DATE: December 1990

TO: All Exec 90 Builders

EXEC 90 ADVISORY BULLETIN - 01

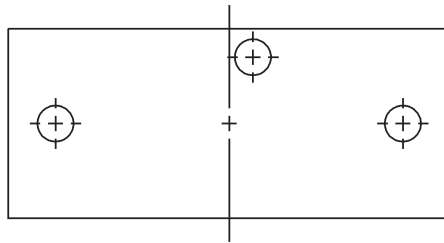
According to our records, your aligner blocks may have been machined incorrectly. Easy identification can be made as follows: Looking at the three tapped holes in the end of the block, the middle hole should be offset approximately 1/8" to one side.

If the middle hole is centered between the other two, both blocks must be returned to RotorWay for exchange.
